CORPORATION  
Crystal River Unit 3  
Ticket No. 50-302

June 26, 1992  
3F0692-18

Subject: Change to Quality Program Description - Reactor Building Painting

PROPOSED CHANGE TO THE QUALITY PROGRAM DESCRIPTION  
FSAR SECTION 1.7

## FSAR SECTION 1.7 TEXT CHANGES

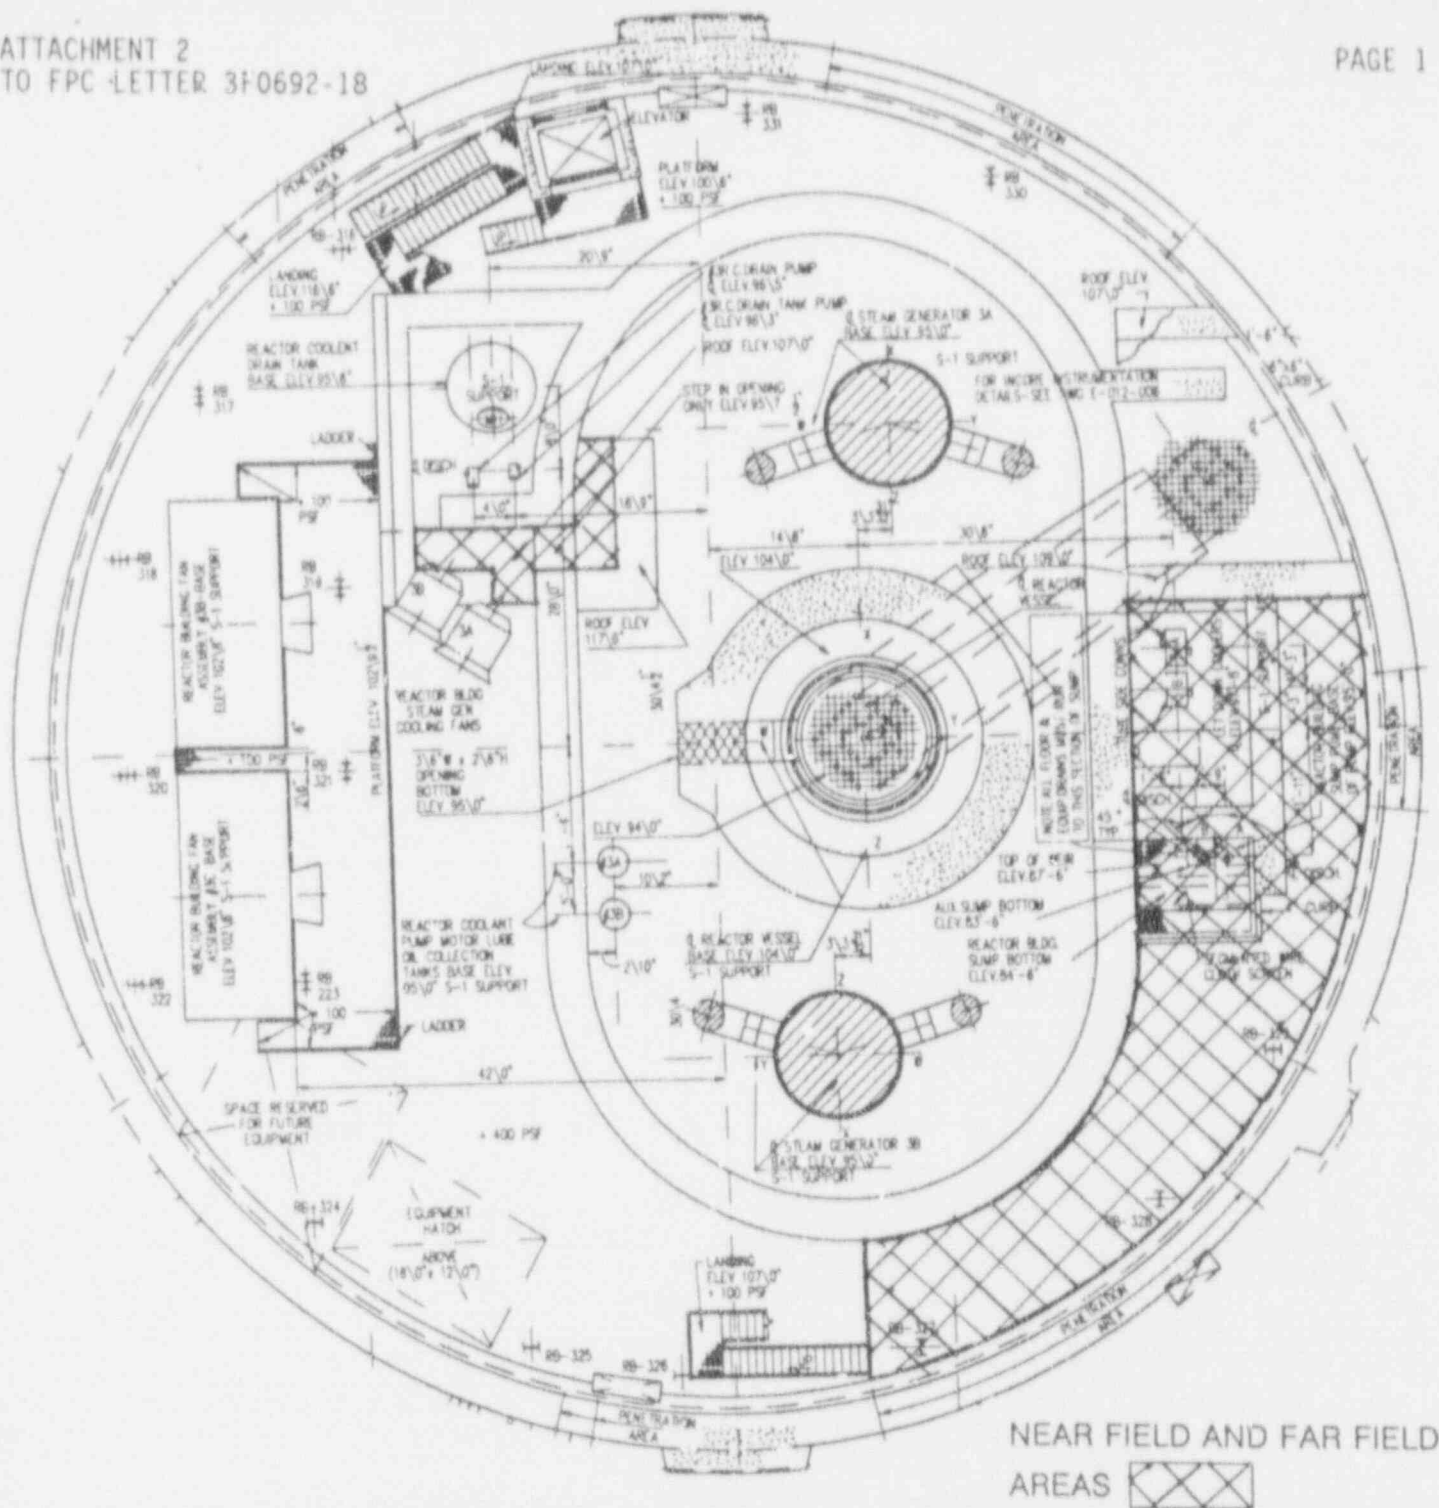
The Quality Program meets the general intent of this guide for portions of the reactor building where protective coating failure could result in the loss of Reactor Building emergency sump operability. The program concerning protective coatings is further delineated in the project specification for Painting & Protective Coatings, RO-3147, and all appropriate plant procedures.

ANSI N101.4-1972 was written to address the protective coating requirements for the construction phase of nuclear power plants. It does not adequately address the more frequently required small amount of painting that is necessary during the operational phase of a plant's life.

RO-3147 meets the requirements of ANSI N101.4-1972 with the following clarifications.

1. REQUIREMENT: Section 1.2.2.1 - "Class I Service Level applies to those systems and components of nuclear facilities. . . ."

CLARIFICATION: FPC considers "Class I Service Level" to be those systems and components which may be exposed to a LOCA atmosphere (i.e., those items in, or to be installed, inside the primary containment building). This definition of Class I Service Level is consistent with the ASTM Committee D-1 "Manual of Coating Work for Light Water Nuclear Power Plant Primary Containment & Other Safety Related Facilities," where failure of the protective coating could have a detrimental effect on plant safety. This definition applies to items in, or to be installed in portions of the primary containment building. The portions of the primary containment where Class I service is necessary is identified in "Evaluation Analysis of Potential Coating Failures" (FSAR Section 1.11, Reference 2). This evaluation establishes "near field" and "far field" locations within the containment where failure of the protective coatings could result in Reactor Building emergency sump blockage and possibly affect emergency sump operability post-LOCA. The "near field" location is an area where failed protective coatings could fall directly into the emergency sump. "Far field" locations are areas where fluid velocities during LOCA recovery are capable of transporting failed protective coatings to the emergency sump and possibly result in sump blockage. RO-3147, Section 3:02 details the requirements for these items and is consistent with ANSI N101.2-1972.

## REACTOR BUILDING 95 FOOT ELEVATION

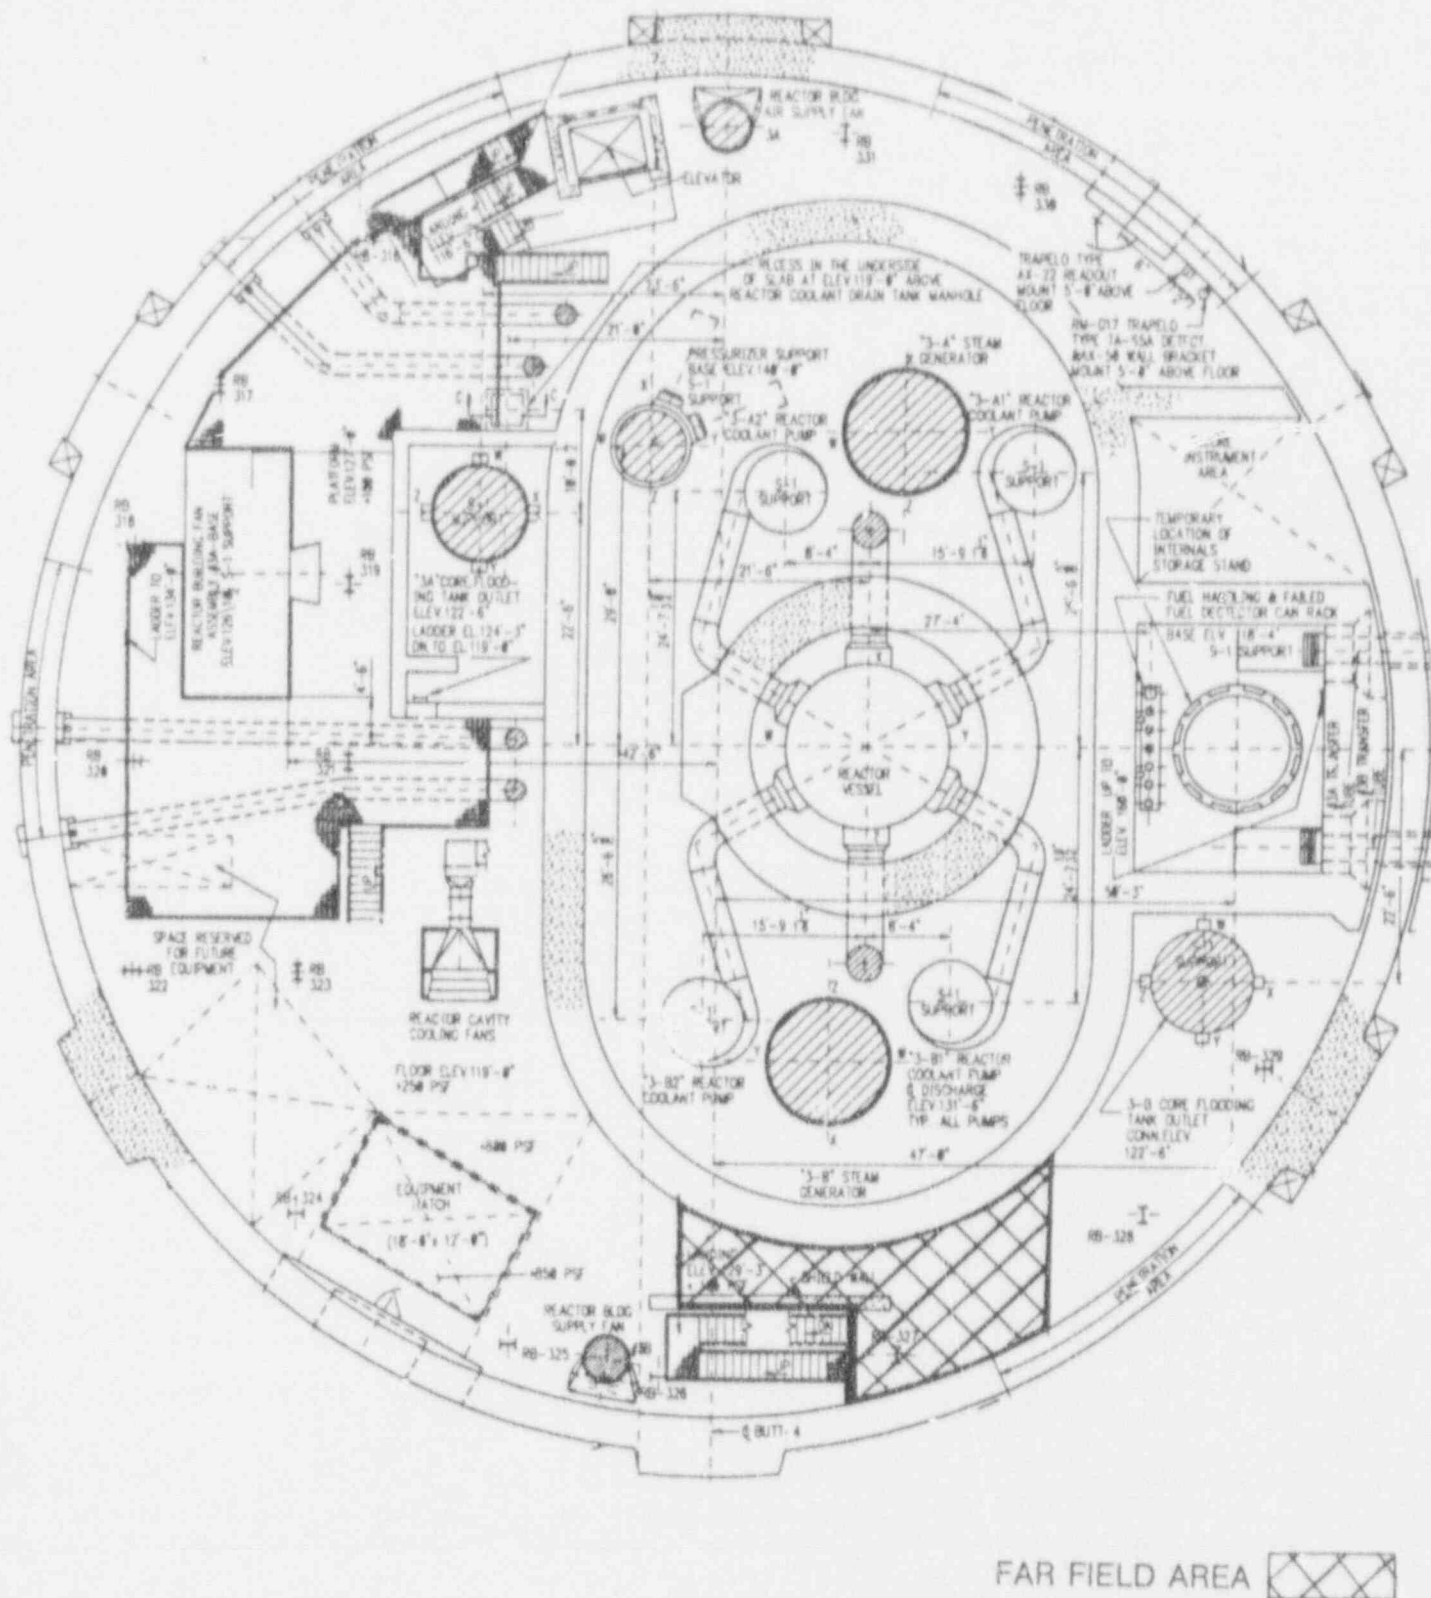
The portion of the RB where failed coatings could fall directly onto the sump are identified as "near field." The "far field" are areas where the transport of the failed coatings could result in the coating particles contributing to ECCS sump blockage. The "near field" is only on the 95 ft elevation of the RB. The "far field" consists of several areas on all elevations of the RB. Attachment 2 contains sketches which show the locations of the "fields." This analysis shows that failure of protective coatings outside those areas regarded as the "near field" and "far field" is not a concern for CR-3 because the fluid flow velocities are inadequate to transport the failed coatings to the ECCS sump.

Based on the analyses, the portions of the RB where failed coatings could fall directly into the sump are identified as the "near field." The areas where the transport of the failed protective coatings could result in the particles contributing to sump blockage are identified as the "far field."

## REACTOR BUILDING 119 FOOT ELEVATION

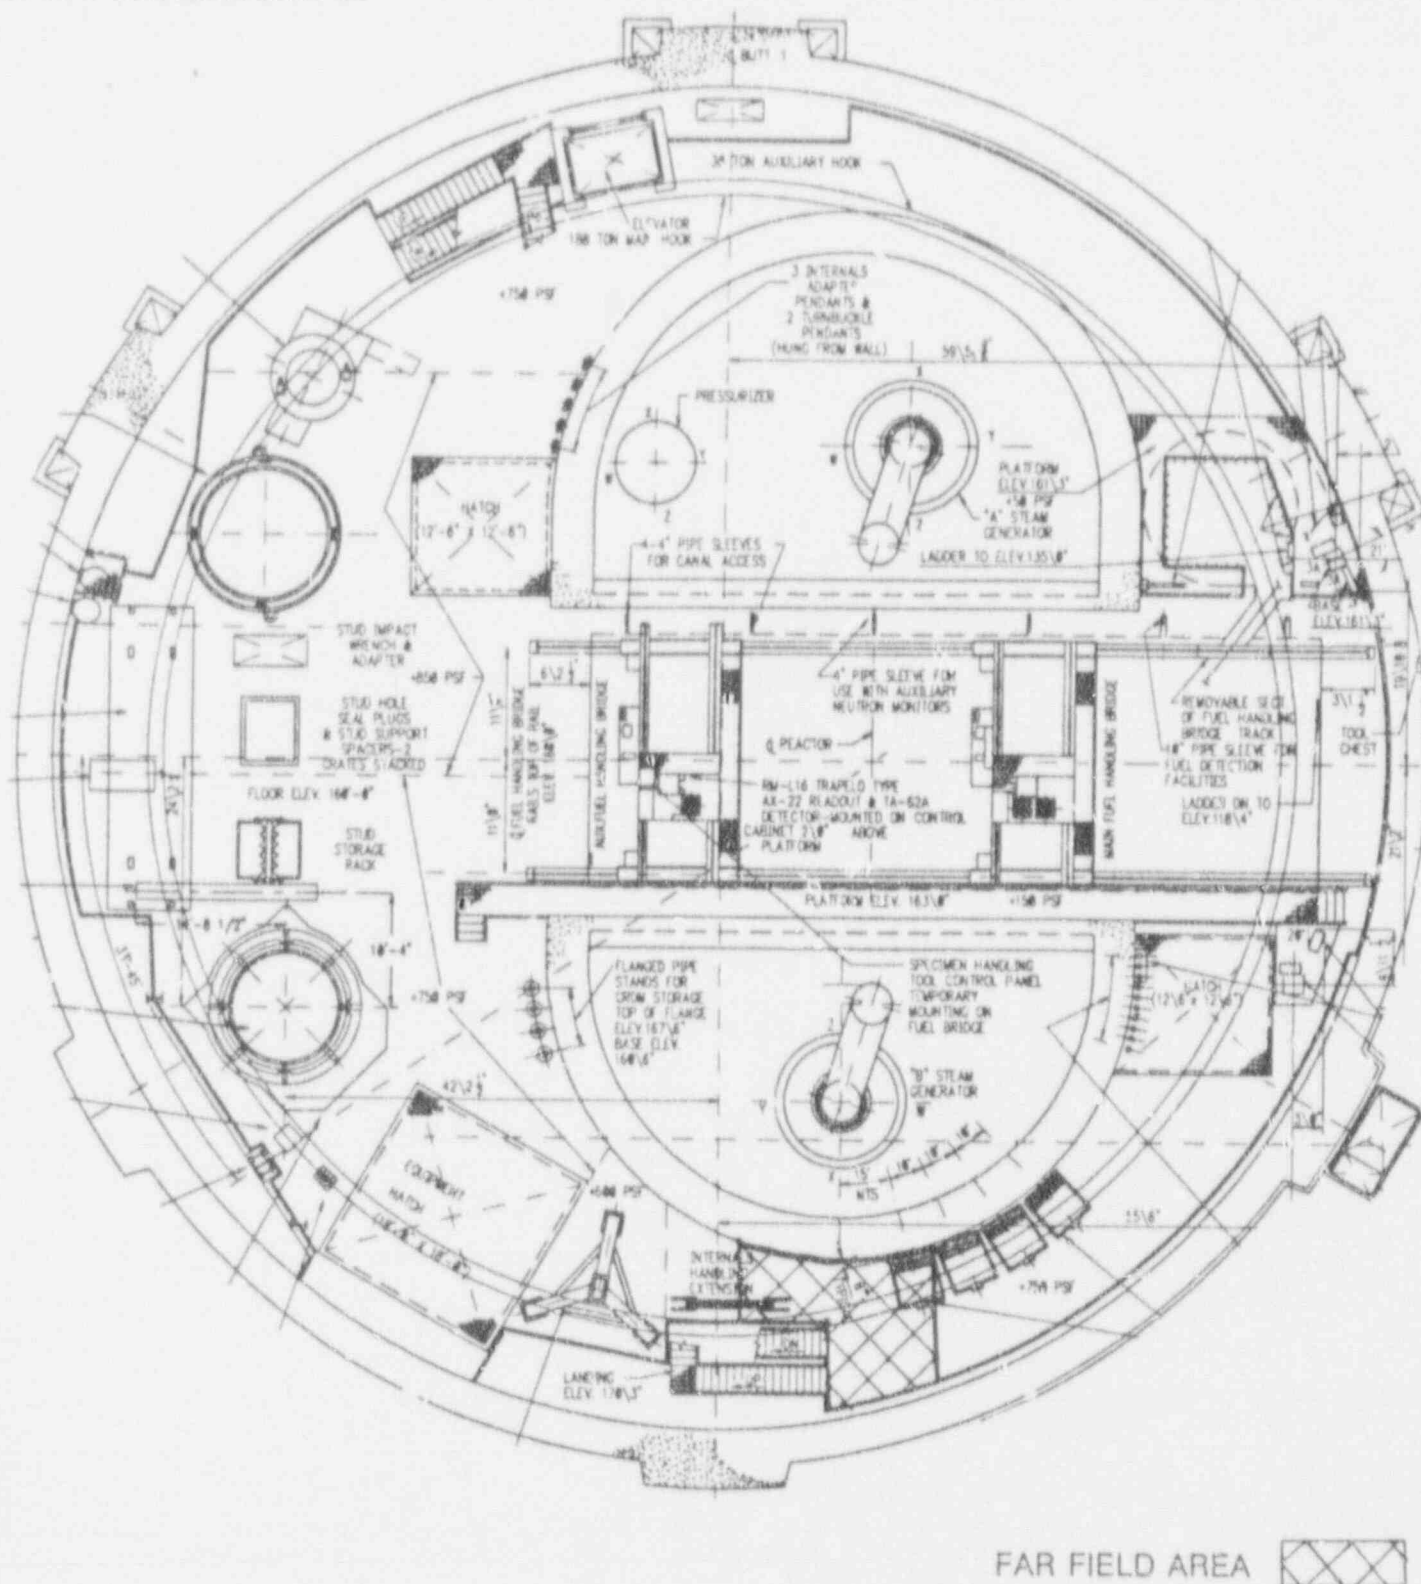
The analyses revealed that failure of protective coatings outside the "near field" and/or "far field" is not a concern. Failed coatings outside of the "near field" cannot fall directly into the RB sump. Failed coatings outside of the "far field" cannot be transported to the RB sump because flow velocities during LOCA recovery will be inadequate to transport coatings large enough to cause clogging. Qualification of the protective coatings per RO-3147 within the identified RB "near fields" and "far fields" will result in the elimination of sump blockage concerns as a result of failed RB protective coatings. Applying qualified coatings to areas beyond the "far field" does not enhance the safety of the plant since those coatings would not be transported to the sump if failure occurred.
